# Access Compliance Report

## Public Rights-of-Way

Intersection ID: 48435	Main Street: BEDLINGTON_RD	Cross Street: SEAMILL_RD	Location: SW
ADA ID: E95B4929A656	Ramp Type: Perp	Initial Pass/Fail: Fail	Overall Compliance: No
Severity Score: 13.75			
Codes/Mitigation Info/Possible Solution		Field Measurements/Component Compliance

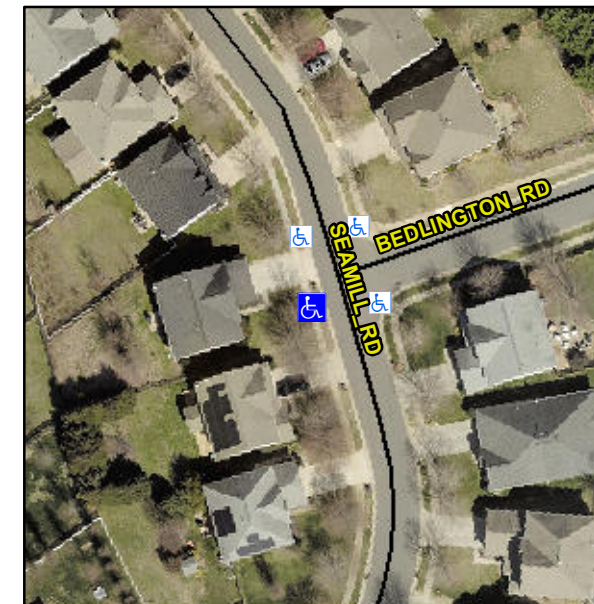
**R304.2.2, R304.5.3**

Compliance	Description	Data	Compliance	Description	Data
N/A	Ramp Length (in)	48.0	No	Ramp Slope (%)	10.7
Yes	Ramp Width (in)	49.0	No	Ramp XSlope (%)	3.7
N/A	Flare Type LT	N/A	N/A	Flare Type RT	N/A
N/A	Flare Slope LT (%)	N/A	N/A	Flare Slope RT (%)	N/A
N/A	Flare Traversable LT?	N/A	N/A	Flare Traversable RT?	N/A
N/A	Landing Length (in)	N/A	N/A	DWS Provided?	N/A
N/A	Landing Width (in)	N/A	N/A	DWS Contrast?	N/A
N/A	Landing Slope (%)	N/A	N/A	DWS Length (in)	N/A
N/A	Landing X Slope (%)	N/A	N/A	DWS Full Width?	N/A
N/A	Landing Curb? (Y/N)	N/A	N/A	DWS Offset (in)	N/A
N/A	Shared Landing?	N/A			
N/A	Gutter Ponding?	N/A	N/A	Gutter Slope (%)	N/A
N/A	Gutter Lip Ht (in)	N/A	N/A	Gutter X Slope (%)	N/A
N/A	Painted X Walk1?	No	N/A	Painted X Walk2?	N/A
	X Walk 1 Direction	To E		X Walk 2 Direction	N/A
N/A	X Walk 1 Width (in)	N/A	N/A	X Walk 2 Width (in)	N/A
	X Walk 1 Slope (%)	3.0		X Walk 2 Slope (%)	N/A
	X Walk 1 X Slope (%)	3.5		X Walk 2 X Slope (%)	N/A

**Remove & Replace Entire Ramp.**
